SETHI HOUSE, PESHAWAR

SITE INSTRUCTIONS

CONSERVATION RECORD DOCUMENT
Site Instructions Sheet

Rope Loop Placement before dismantling of Non-Historic Portion

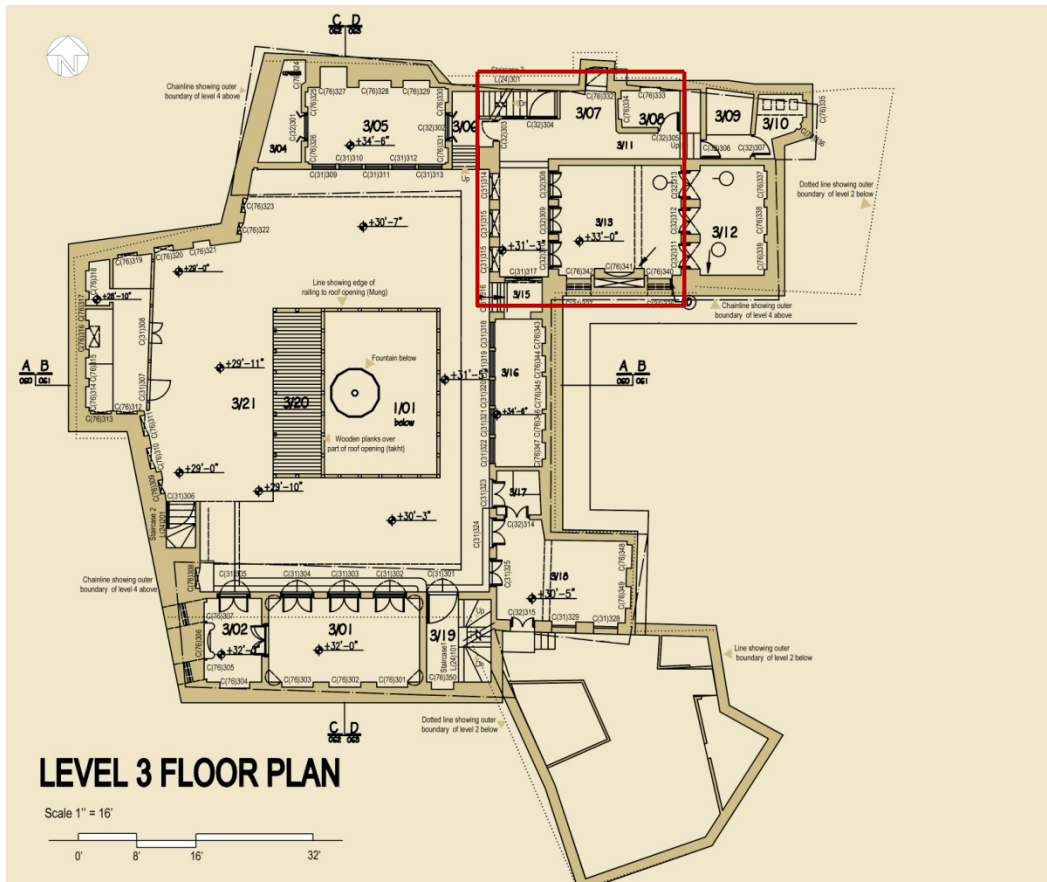
1. In view of the dangerous and precarious mid and non-historic section of the Sethi house, structural consultant, Engr. Amin Tariq has advised that the structure in danger must be tied together with "rope loop placement" before demolition.
2. The rope is to be 3 strands of stainless steel post tension wire, 8mm in thickness roped together
3. The wall is to be divided into 3' high centres, which will result in 4 loops along level 3
4. U Clamps and Buckle Clamps must be used to tighten the loops.
5. Work must be undertaken before dismantling of non-historic portion

Title of Works:
Demolition of Non-Historic portion

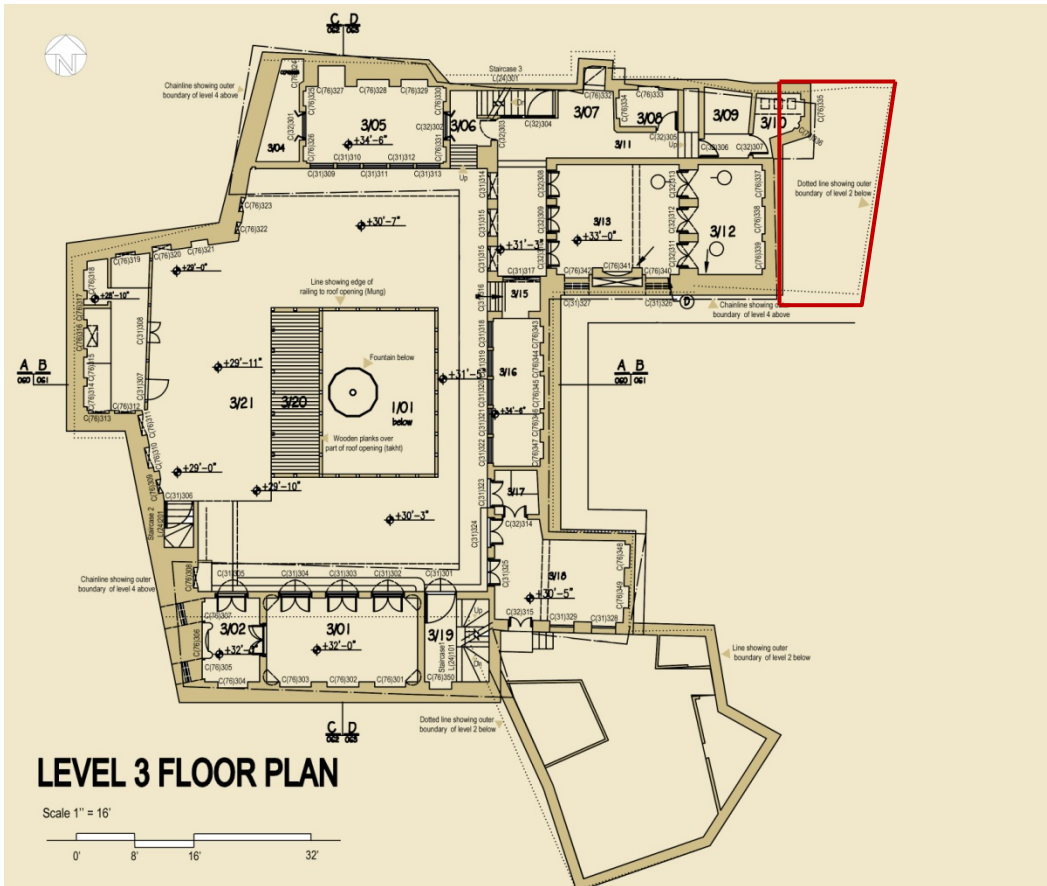
- Conduct demarcation and thorough inspection of the area to be demolished
- Check the structure for likely hazards are cut off or diverted, such as electric power lines or cables, gas reticulation and unsafe structural members
- Provisions like warning signs shall be installed clearly for the safety for pedestrian and vehicle movement.
- Check the relationship and the condition of adjoining structures and buildings and work out to minimize the disturbance to surroundings during demolition work
- Prepare a method statement which shall detail all aspects of proposed dismantling and demolition work. It must describe the extent of work, the type of equipment to be used and the proposed method of removing each part of structure e.g. roof, walls, floors

- All temporary works and protective structures should be erected by contractor before demolition begins
- Where there is a danger of material falling on the workers or public below, the entire face of the scaffold must be covered with small mesh netting.
- Where a structure's stability may be affected by the dismantling temporary bracing, and guys, are to be provided to restrain the remaining members.
- Maintain safety precautions as required for the protection of persons and property on or adjacent to the site
- The use of excavators, vibrating rollers or any disturbing/vibratory equipment is strictly prohibited in historically valued building vicinities.

- Dismantling of roof materials like brick and mud; Woodwork dismantling and preservation for future use; Dismantling of Brick Masonry Walls
- Once dismantling and demolition work has started, the same is to be continued till the completion, promptly and expeditiously.
- Support is to be provided for members of framed structures before cutting them.
- Conduct operations in a manner that minimizes the spread of flying particles and dust.
- Remove any additional small "out" or miscellaneous structures that have not been indicated in the documents unless otherwise instructed by the Client.

Dismantling roof level 4; New Waterproofing

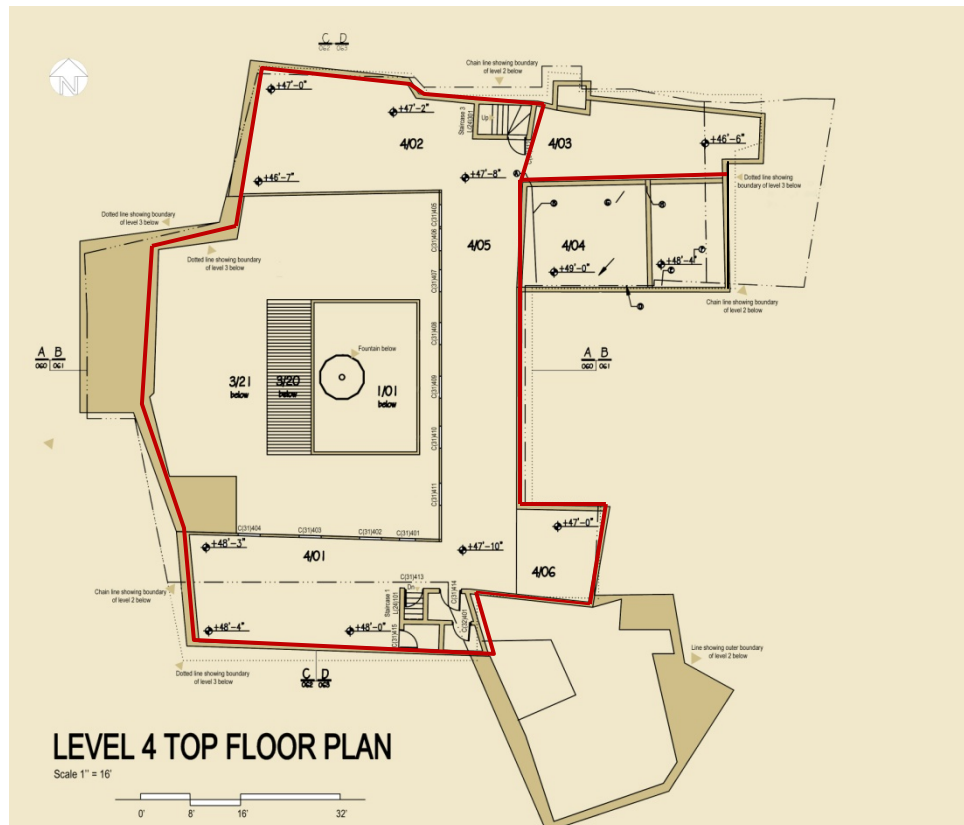
1. Reasons for Opening Roof
 - Waterproofing: Damaged waterproofing affecting structure. Treatment to structure cannot be possible unless the roof is opened and assessment of damage made.

- Structural Overloading: Layers of earth filling have been placed over time, reaching up to three feet in some areas. This is causing unnecessary load on the structure, as well as allowing water to seep through.

- Damage to structural Timber: Upon removal of layers of earth fill, the condition of the wooden joists was observed as being highly damaged. Rainwater retention and the absorption of moisture in the earth fill has caused the structural timber to be highly damaged.

2. Structural Advise: Upon discussions with the structural expert, Engr. Amin Tariq, it has been advised that the earth filling must be removed to relieve structural overloading, hence extending the life of the structure.

3. Timber Rafters: It has been concluded that as much as possible the timber structure must be maintained, treating them in situ. Damaged rafters will be dealt with depending upon their degree of decay:

- 80% Damage: Rafters must be replaced with new Deodar, treated with anti termite
 - 50% Damage: Rafters must not be removed or replaced, except the decayed or damaged section. This segment must be strengthened by attaching new timber (deodar) pieces. The additions must be jointed with a special Wooden joint known as 'Qalam'

- 30% or less: All those found in reasonable condition must be cleaned and left in position

All rafters must be treated with anti termite 'Biflex' of German origin.
4. Date Palm Matting: Remains of date palm matting must be removed as it is in a highly damaged condition and is fulfilling none of its intended use

5. Khajji Planks: Planks found between rafters must be removed and replaced with deodar wood planks, treated with anti termite.
6. Anti-Termite: All structural woodwork must be treated with 2-3 coats of anti-termite, BILFEX, of German origin.

7. Bitumen: In order to avoid a fire hazard, the process of cold application of bitumen must be undertaken. The rate of application must be 7 lbs/ft² on all timber planks

8. Polyethylene layer: for protection against rain, a layer of polyethylene minimum of 5mm must be placed. The sheet must be larger than the area of the room it is being placed in so that it can be turned.

9. Insulation: A minimum 8mm layer of Jumbolon must be placed on the entire surface for protection against water and moisture.
10. The entire surface must be covered with a 2" minimum layer of lime-kankar mix. This must be laid in order to provide slop according to the rainwater disposal plan

11. Water-proofing layer of bitumen and polyethylene sheet to be taken up to parapet walls in order to form a fillet hence providing

12. Brick and Mortar: The entire surface must be laid with 6"x12"x2" and 8"x4"x2" bricks. It is essential that the original bricks removed from original roof. These must be laid with 1:3 mortar, where 1 part is lime water also known as Kalie and 3 parts is file lime. The bricks must be used on a 1" thick base. A final layer of grouting must be applied with a white lime-fine lime 1:1 mix.

Dismantling roof level 3; New Waterproofing

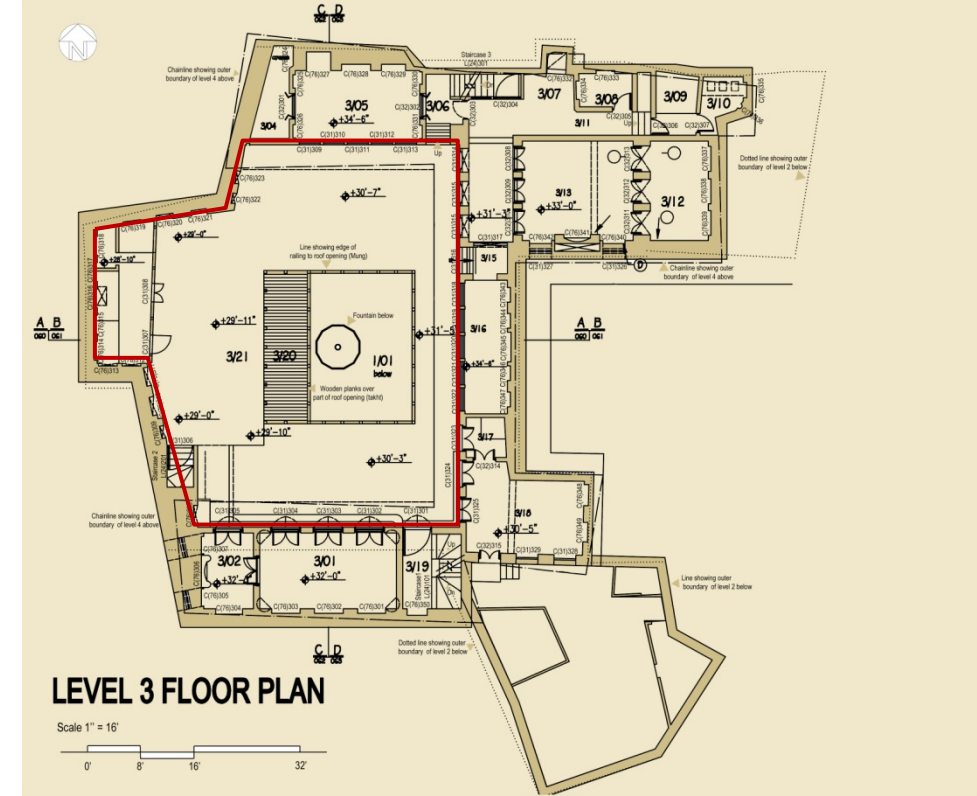
1. Reasons for Opening Roof
 - Waterproofing: Damaged waterproofing affecting structure. Treatment to structure cannot be possible unless the roof is opened and assessment of damage made.

- Structural Overloading: Layers of earth filling have been placed over time, reaching up to three feet in some areas. This is causing unnecessary load on the structure, as well as allowing water to seep through.

- Damage to structural Timber: Upon removal of layers of earth fill, the condition of the wooden joists was observed as being highly damaged. Rainwater retention and the absorption of moisture in the earth fill has caused the structural timber to be highly damaged.

2. Structural Advise: Upon discussions with the structural expert, Engr. Amin Tariq, it has been advised that the earth filling must be removed to relieve structural overloading, hence extending the life of the structure.

3. Timber Rafters: It has been concluded that as much as possible the timber structure must be maintained, treating them in situ. Damaged rafters will be dealt with depending upon their degree of decay:

- 80% Damage: Rafters must be replaced with new Deodar, treated with anti termite
 - 50% Damage: Rafters must not be removed or replaced, except the decayed or damaged section. This segment must be strengthened by attaching new timber (deodar) pieces. The additions must be jointed with a special Wooden joint known as 'Qalam'

- 30% or less: All those found in reasonable condition must be cleaned and left in position

All rafters must be treated with anti termite 'Biflex' of German origin.
4. Date Palm Matting: Remains of date palm matting must be removed as it is in a highly damaged condition and is fulfilling none of its intended use

5. Bricks used to fill gaps between rafters, while deodar wood planks to be used in areas which are worse off and along the walls
6. Anti-Termite: All structural woodwork must be treated with 2-3 coats of anti-termite, BILFEX, of German origin.

7. Bitumen: In order to avoid a fire hazard, the process of cold application of bitumen must be undertaken. The rate of application must be 7 lbs/ft² on all timber planks

8. Polyethylene layer: for protection against rain, a layer of polyethylene minimum of 5mm must be placed. The sheet must be larger than the area of the room it is being placed in so that it can be turned.

9. Insulation: A minimum 8mm layer of Jumbolon must be placed on the entire surface for protection against water and moisture.
10. The entire surface must be covered with a 2" minimum layer of lime-kankar mix. This must be laid in order to provide slop according to the rainwater disposal plan

11. Water-proofing layer of bitumen and polyethylene sheet to be taken up to parapet walls in order to form a fillet hence providing protection to the joint of parapet and roof.

12. Brick and Mortar: The entire surface must be laid with 6"x12"x2" and 8"x4"x2" bricks. It is essential that the original bricks removed from original roof. These must be laid with 1:3 mortar, where 1 part is lime water also known as Kalie and 3 parts is file lime. The bricks must be used on a 1" thick base. A final layer of grouting must be applied with a white lime-fine lime1:1 mix.

Title of Works:
Repairing of Cornice

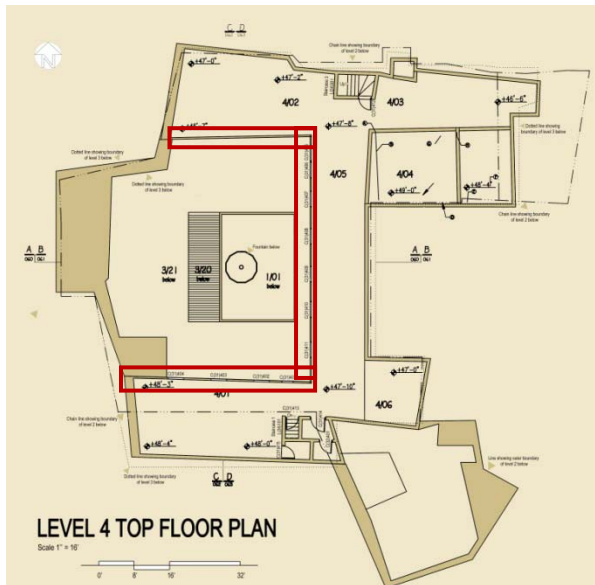
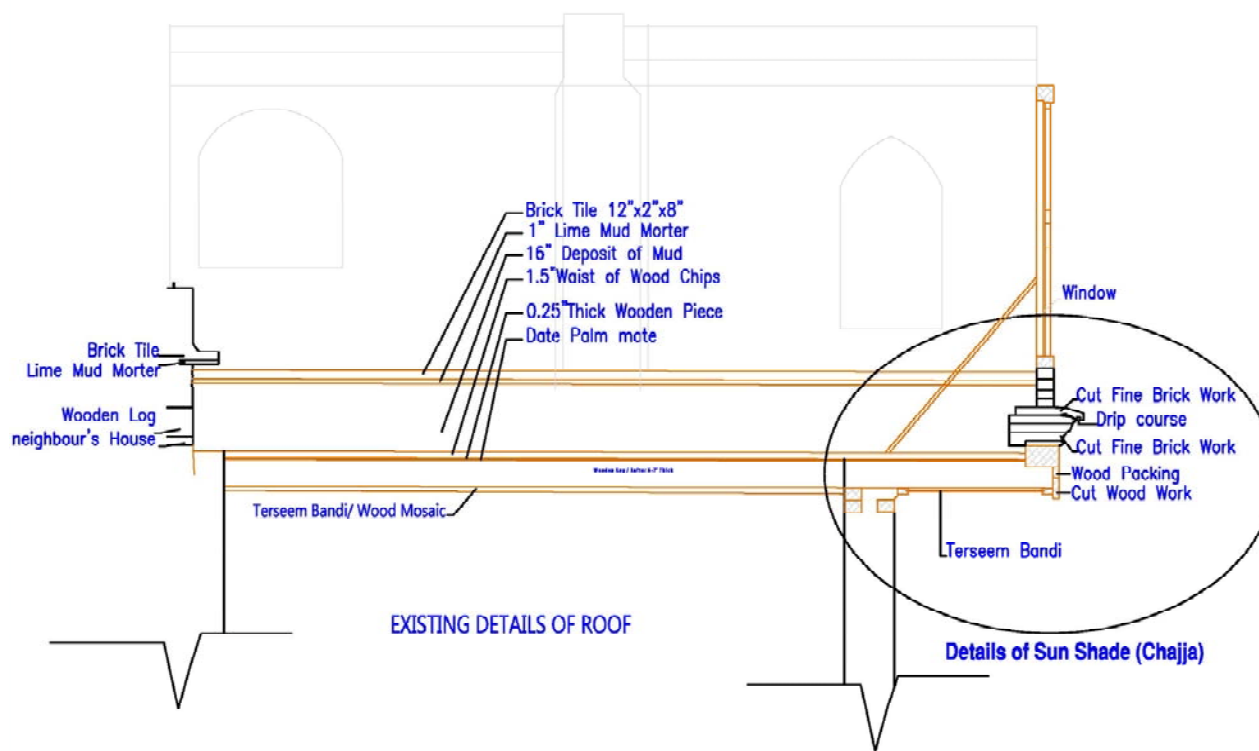
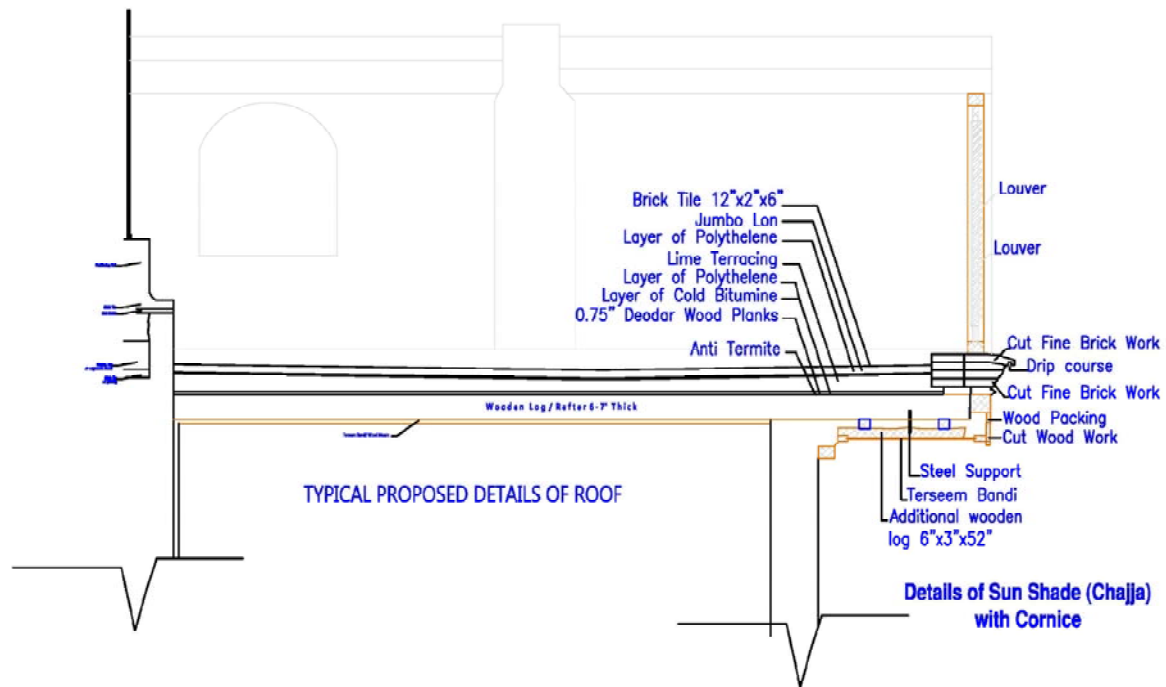
1. Upon the beginning of the work of fixing the highly damaged wooden frames began, the cornice which was also in a damaged condition collapsed along with the wooden Purdah Wall. Due to this collapse both the cornice and the purdah wall had to be reconstructed to not only rectify the above mention problem but also to stabilize the cornice an wood work.
2. The damaged woodwork and also been filled in with brick which required removal.
3. It is imperative that existing bricks found in the cornice be reused to reconstruct it according to sample and design of the original as shown in drawings. At the advent of lack of old brick, new brick may be used but it must be shaped according to the original.

Title of Works:
Wooden Purdah Wall and Louvers

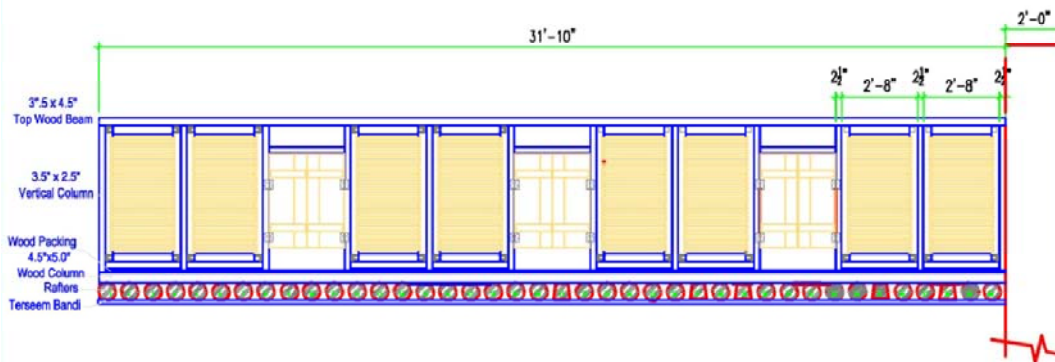
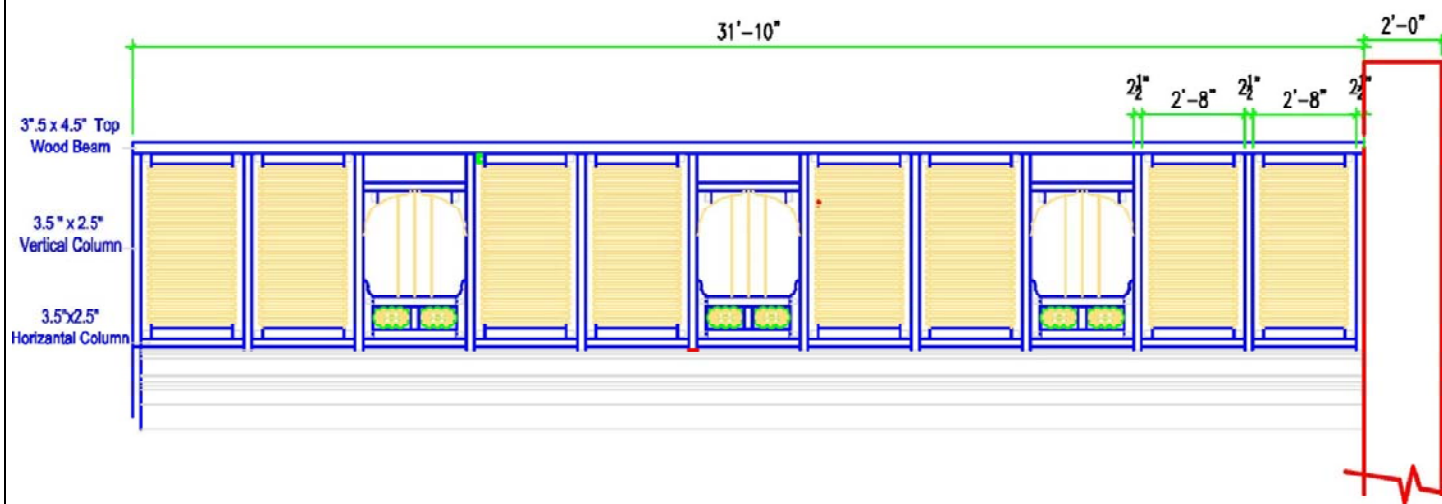
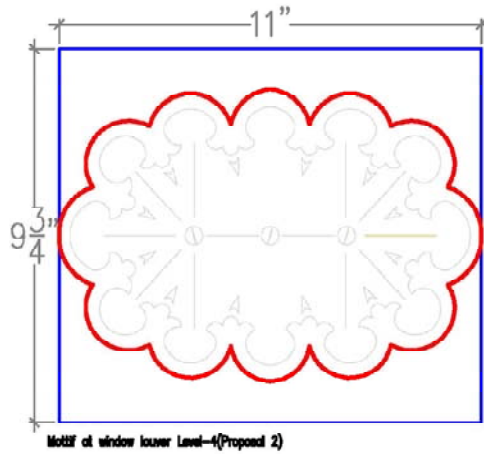
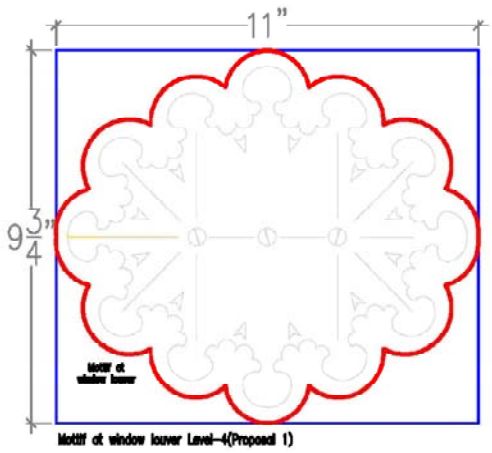
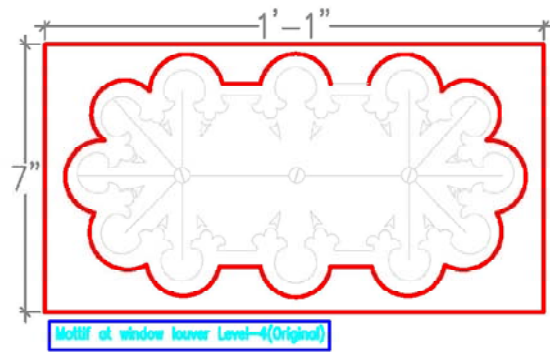
1. Due to excessive damage over the past years the wooden purdah wall along the level 4 roof required stabilization. Upon repair, due to the damaged cornice the entire wooden structure collapsed. Hence entire purdah wall required reconstruction

2. Damaged wood to be reused after planing and fixed according to the original design. It must be secured to avoid further mishap.
3. Although damaged shutter were found in some of the openings but no evidence indicated the treatment of other panels.

4. For filling of the other panels, a survey was conducted of architectural language of surrounding buildings. Eventually a design was decided upon based on a louvered ventilator found inside the Sethi House itself.

5. Sample of exact profile of proposed panels must be prepared. These louvered panels must be placed according to the drawing prepared for this purpose.

6. No treatment to the wood shall be made until decision has been taken
7. Ensure that the entire structure has been fixed so that the wooden purdah wall will not destabilize again.
